ADDENDUM NO. 1

**TITLE: BOONE CENTRAL POST TENSION TRACK AND FOOTBALL FIELD PROJECT
BOONE CENTRAL PUBLIC SCHOOLS**

PROJECT: REGA NO. 121271

DATE OF ISSUE: March 22, 2013

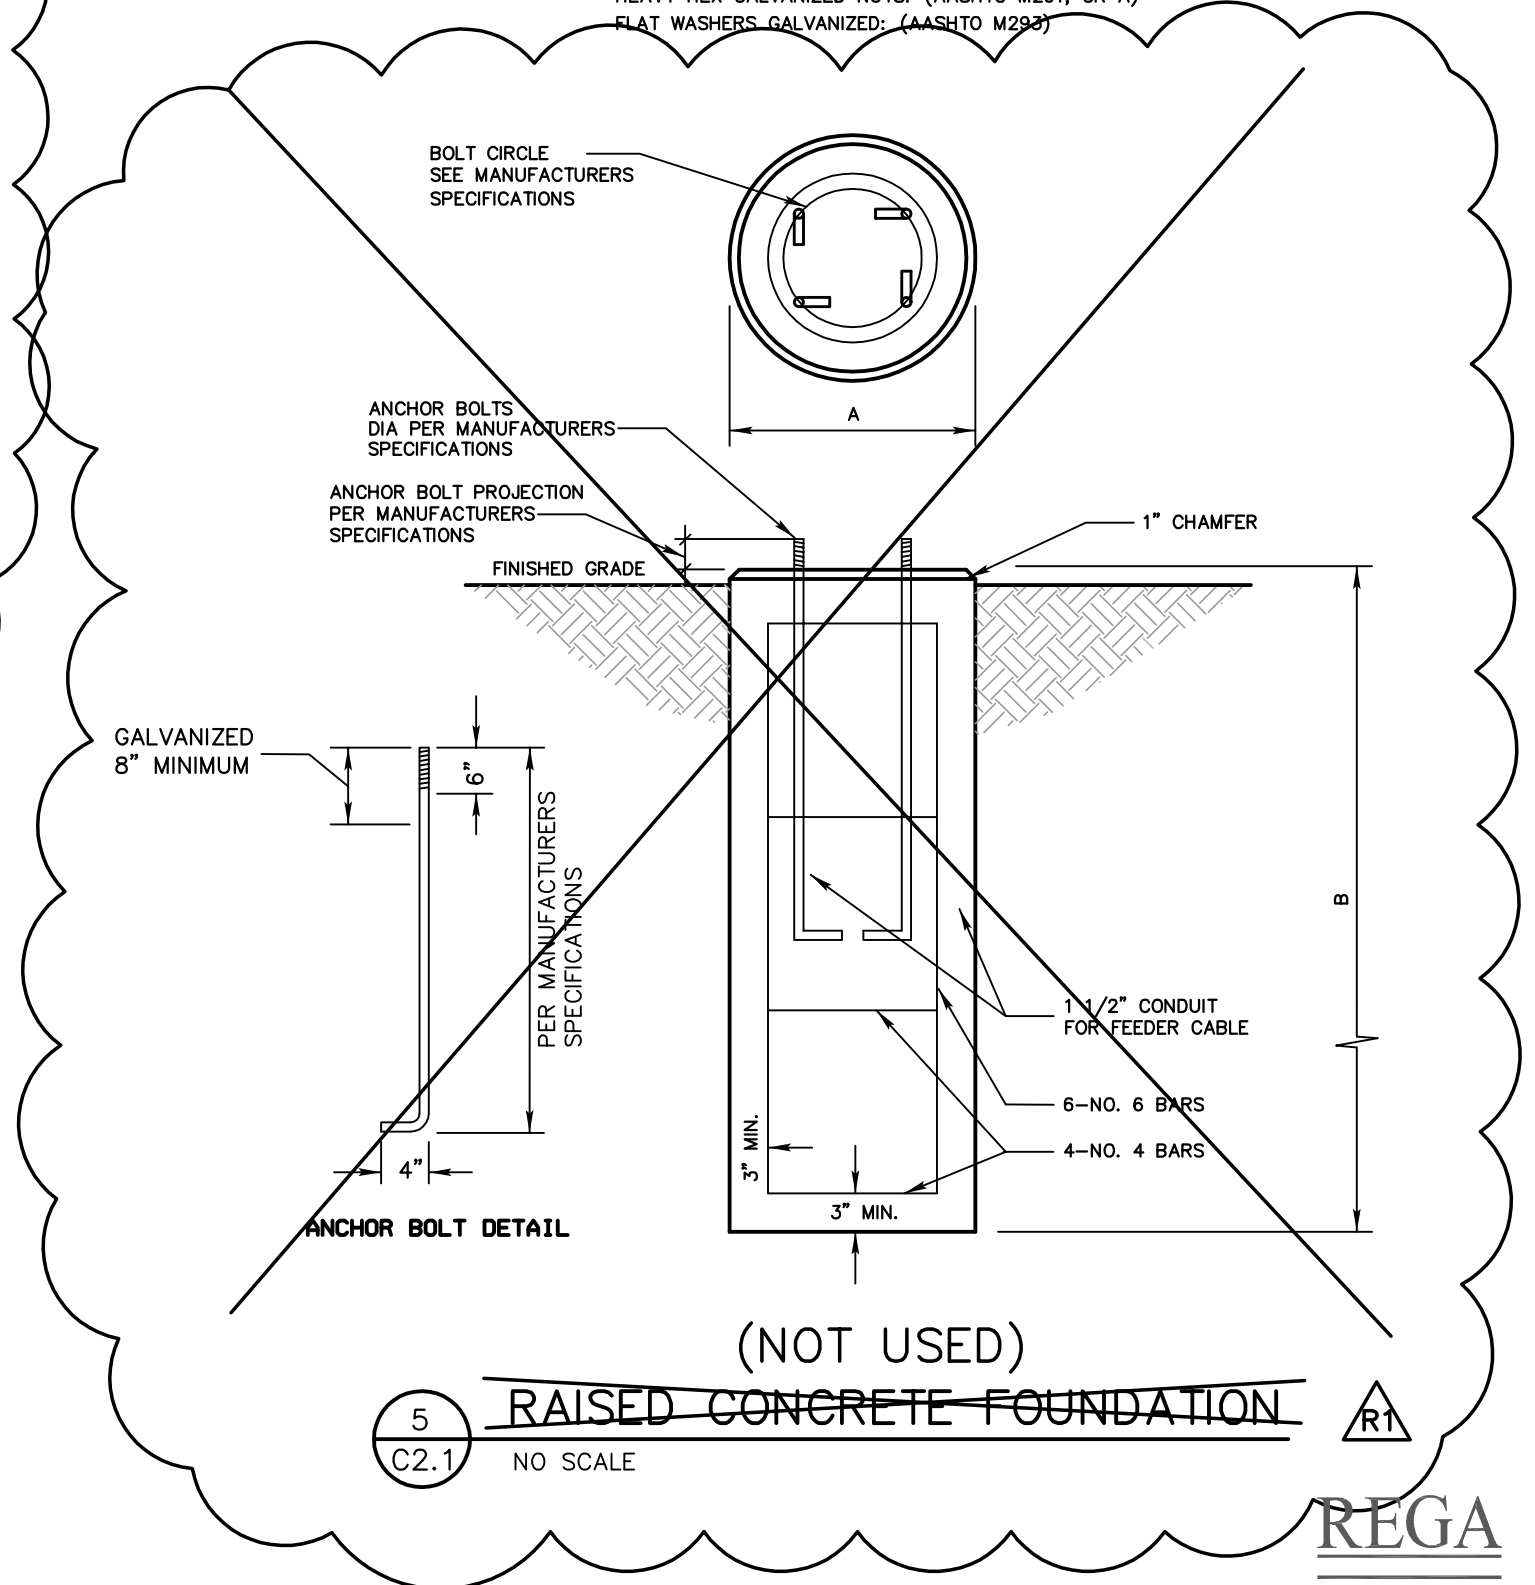
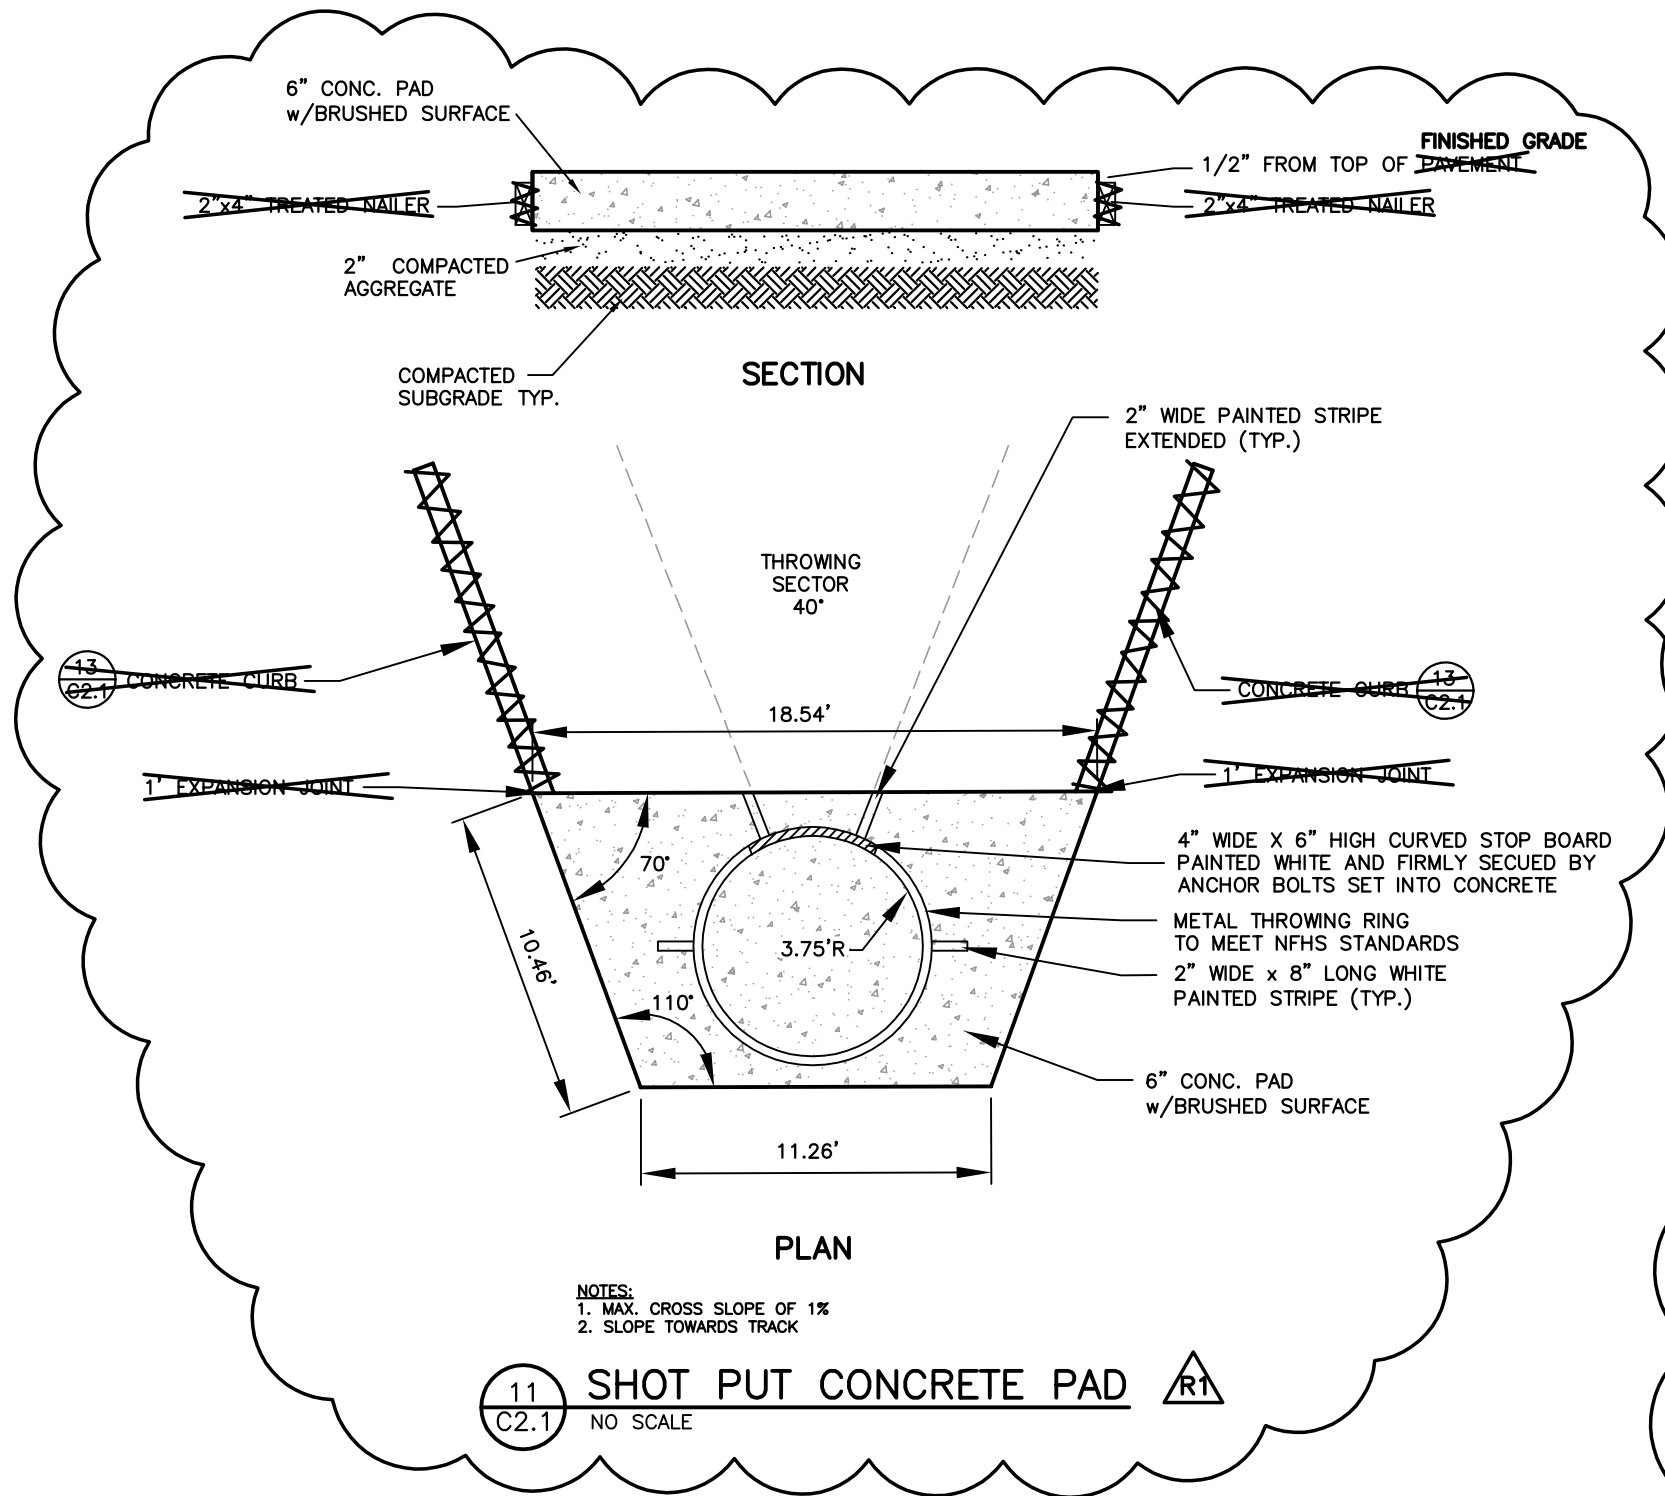
Delete: Detail 5 in its entirety

Revise: Detail 11

ISSUED FOR:	DATE:	BY:
DETAIL 11/C2.1, REMOVE 2"x4" NAILER, REMOVE CONCRETE CURB AND 1/2" EXPAN. JOINT,	03/22/13	SDB
DETAIL 5/C2.1, NOT USED	03/22/13	SDB

REF. SHT# C2.1

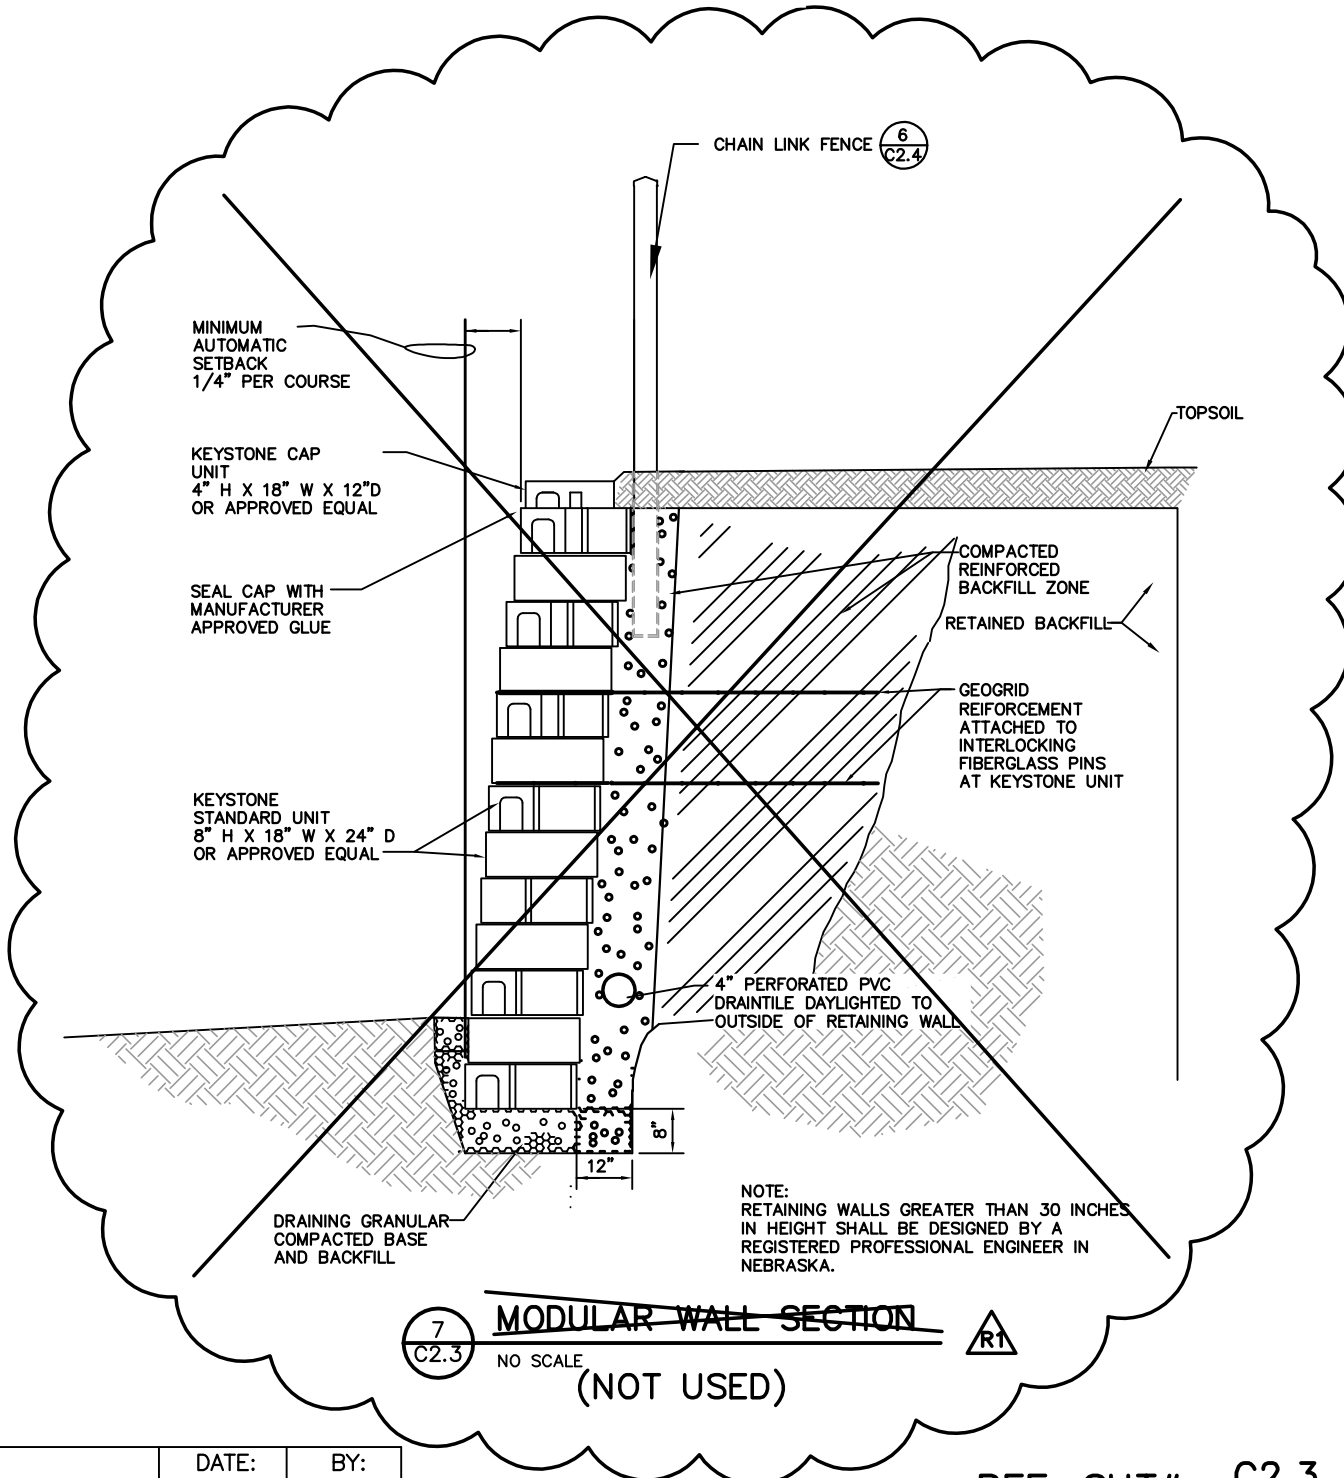
Delete: Detail 7 in its entirety

ISSUED FOR:	DATE:	BY:
DETAIL 7/C2.3, NOT USED	03/22/13	SDB
